S4.55 MODIFICATION

S4.55 MODIFICATIONS	
Change ID	Name
Ch-01	Courtyard wall moved into courtyard
Ch-02	Alfresco deck reshaped
Ch-03	New window to first floor bathroom (W29)
Ch-04	Western wall on first floor moved forward by 650mm & balcony removed
Ch-05	New window to ground floor Dining (W20)
Ch-06	W04 - Kitchen window size change
Ch-07	Skylights relocated from stairwell to hallway
Ch-08	Eastern balcony screen reduced in length
Ch-09	Cellar footprint revised to include sauna

S4.55 MODIFICATION		
project	1130 PITTWATER RD	
	COLLAROY	
drawing	COVER SHEET	
drawn	SM / PC	checked MA
date	09.02.24	scale @ A3
project no	2_23_10	drawing no D0000
		issue F

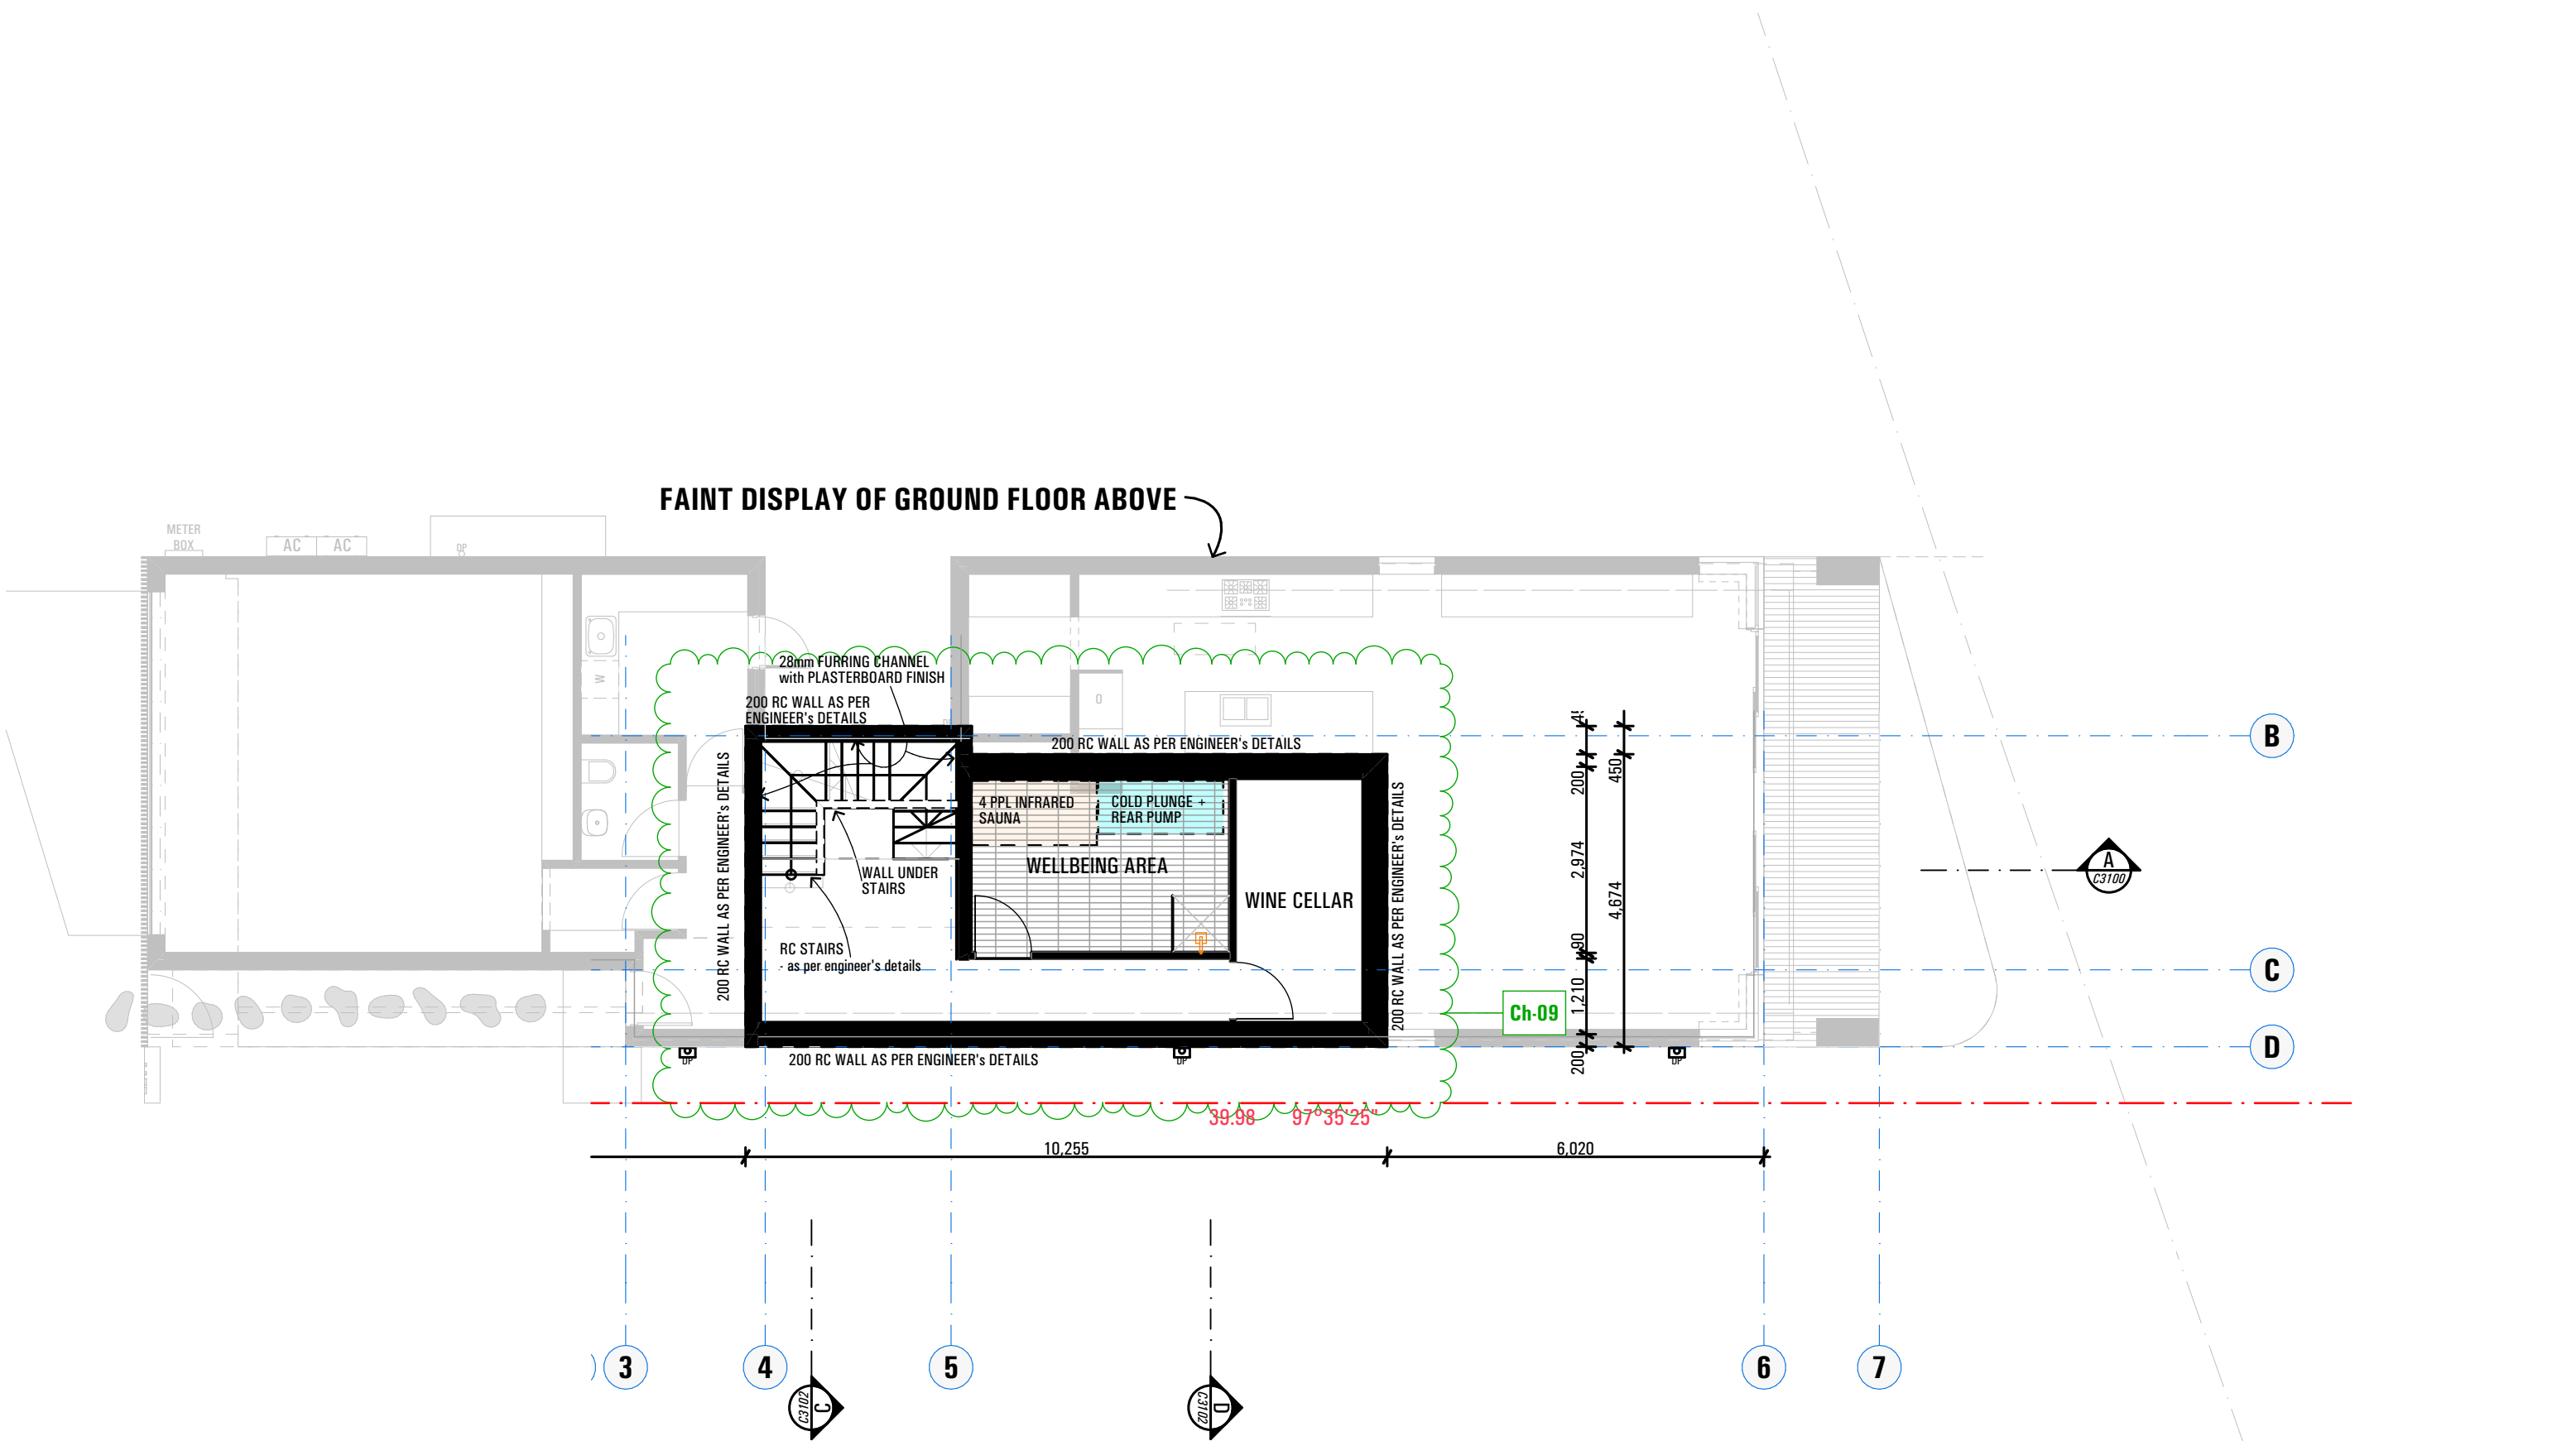
S4.55 MODIFICATIONS	
Change ID	Name
Ch-01	Courtyard wall moved into courtyard
Ch-02	Alfresco deck reshaped
Ch-03	New window to first floor bathroom (W29)
Ch-04	Western wall on first floor moved forward by 650mm & balcony removed
Ch-05	New window to ground floor Dining (W20)
Ch-06	W04 - Kitchen window size change
Ch-07	Skylights relocated from stairwell to hallway
Ch-08	Eastern balcony screen reduced in length
Ch-09	Cellar footprint revised to include sauna

project no2_23_10drawing noD2102issueF

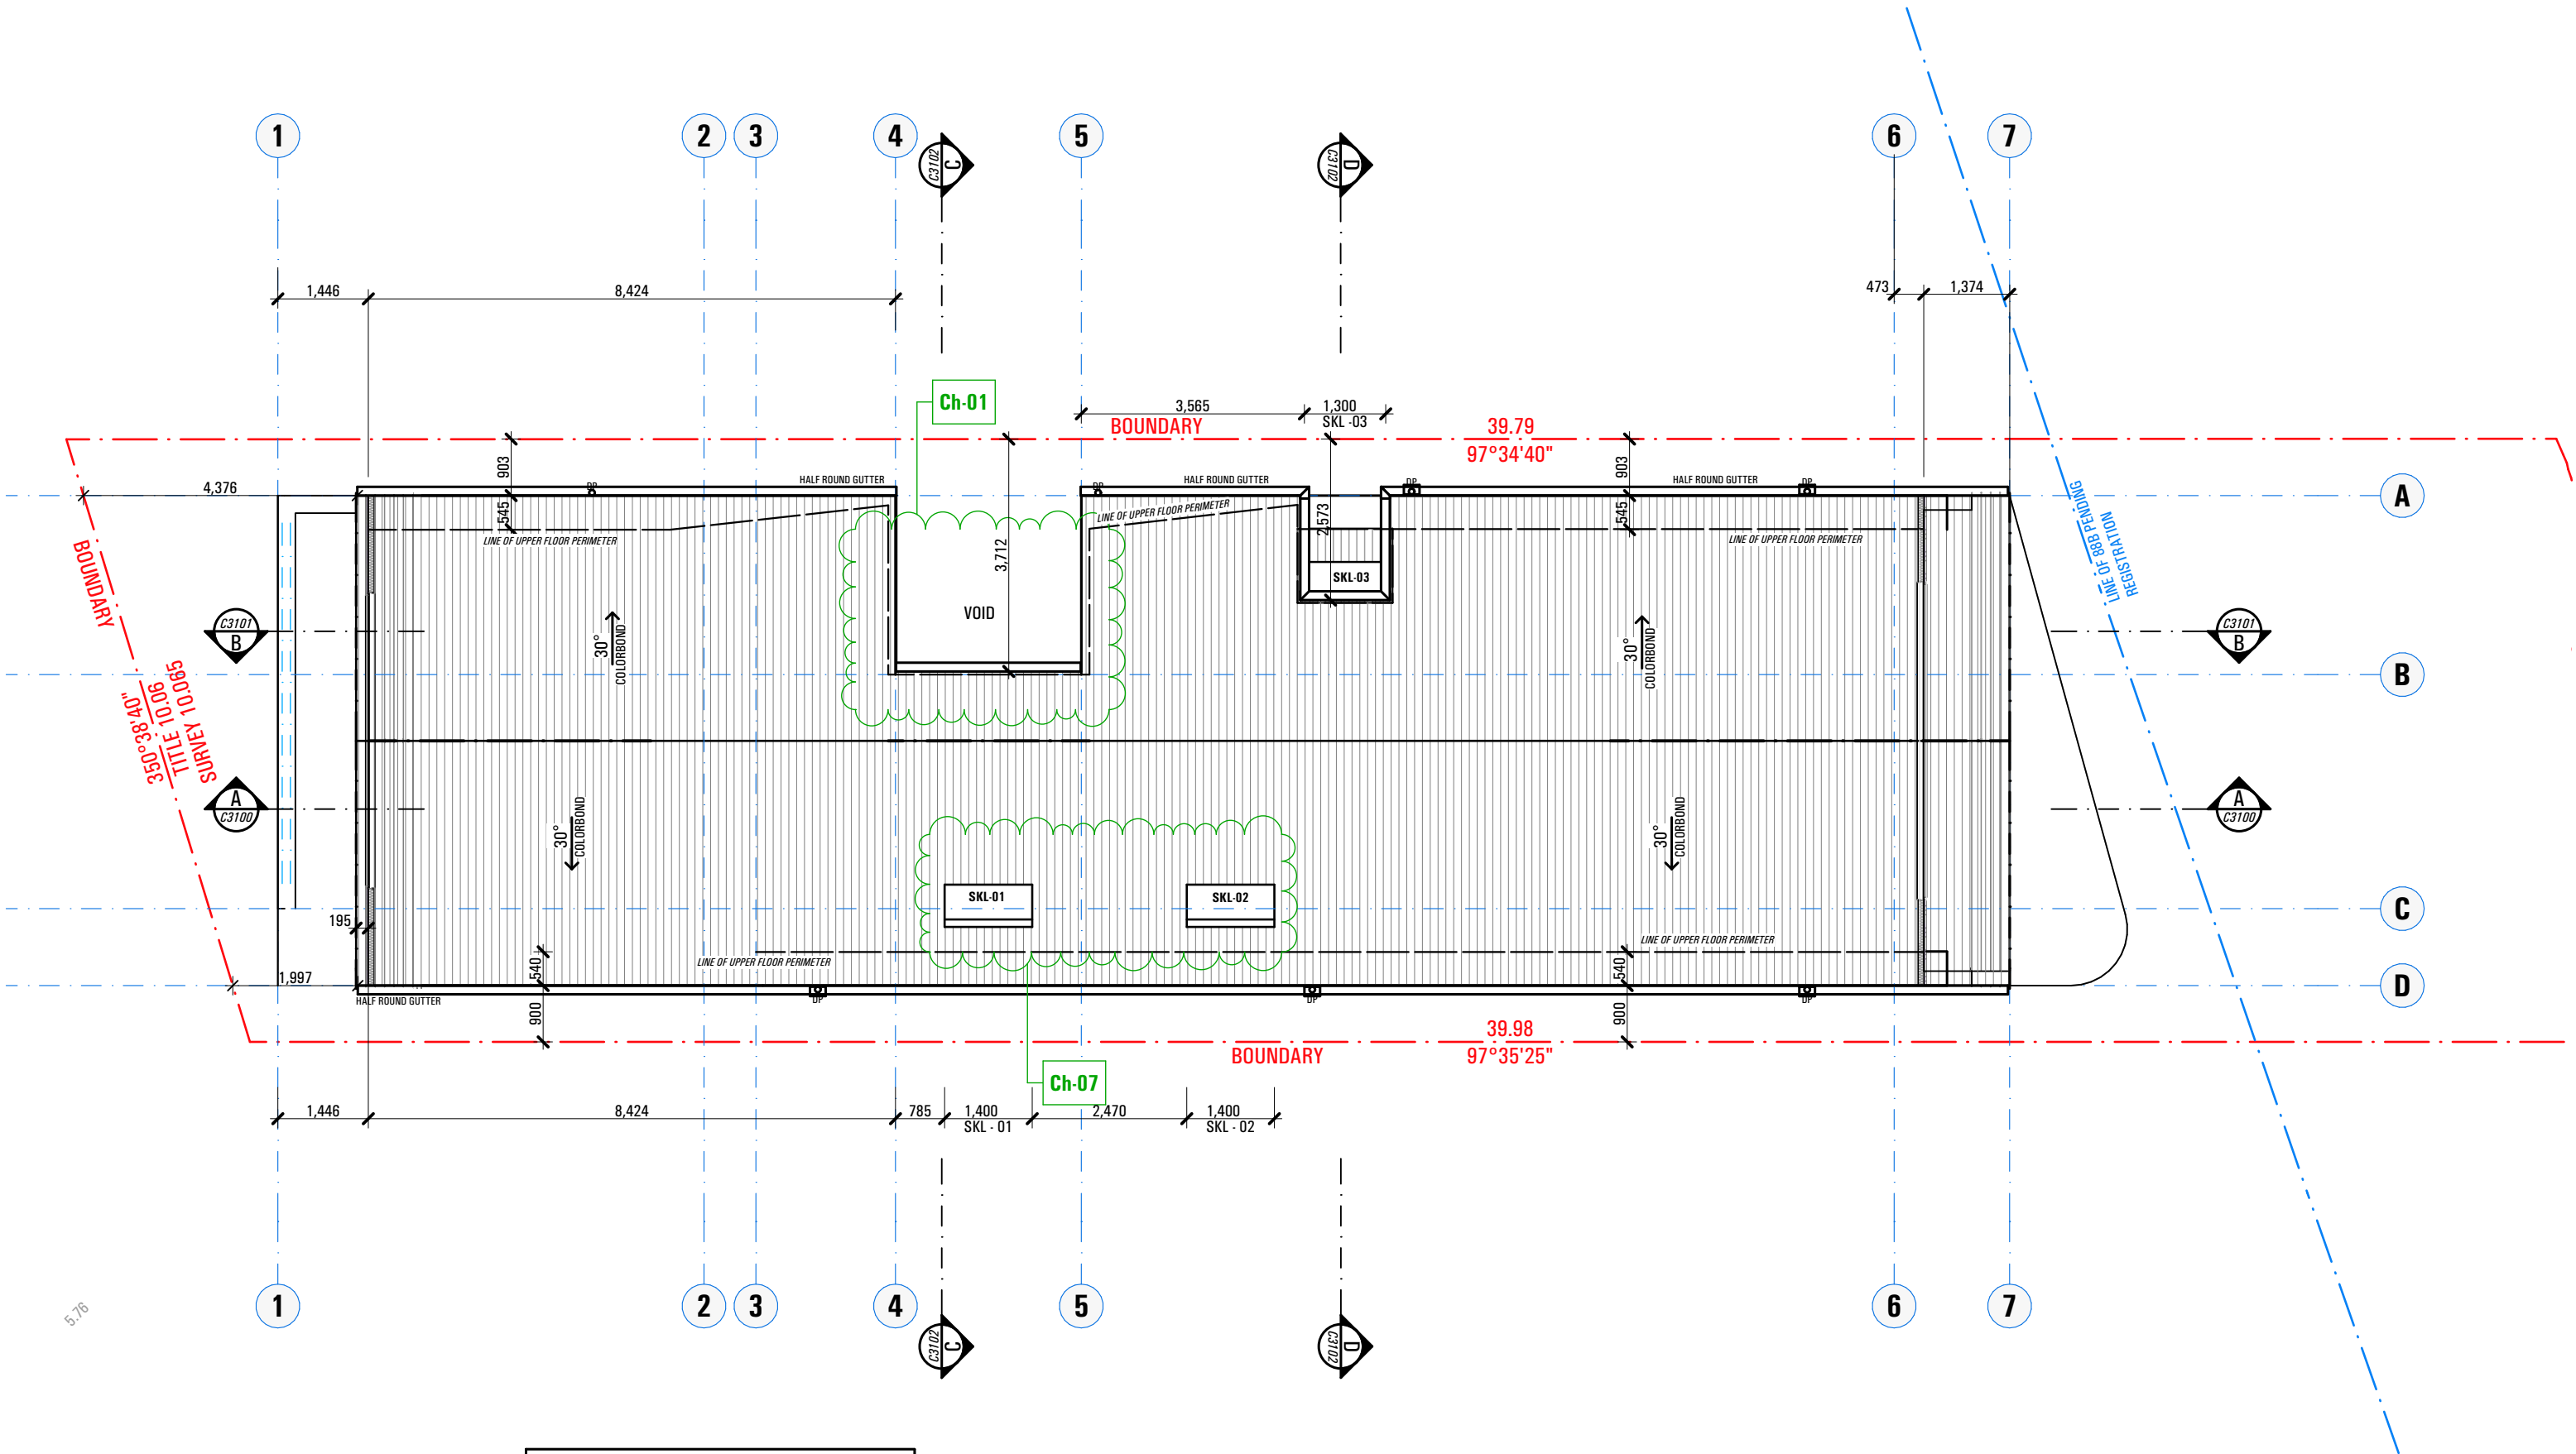
S4.55 MODIFICATIONS	
Change ID	Name
Ch-01	Courtyard wall moved into courtyard
Ch-02	Alfresco deck reshaped
Ch-03	New window to first floor bathroom (W29)
Ch-04	Western wall on first floor moved forward by 650mm & balcony removed
Ch-05	New window to ground floor Dining (W20)
Ch-06	W04 - Kitchen window size change
Ch-07	Skylights relocated from stairwell to hallway
Ch-08	Eastern balcony screen reduced in length
Ch-09	Cellar footprint revised to include sauna
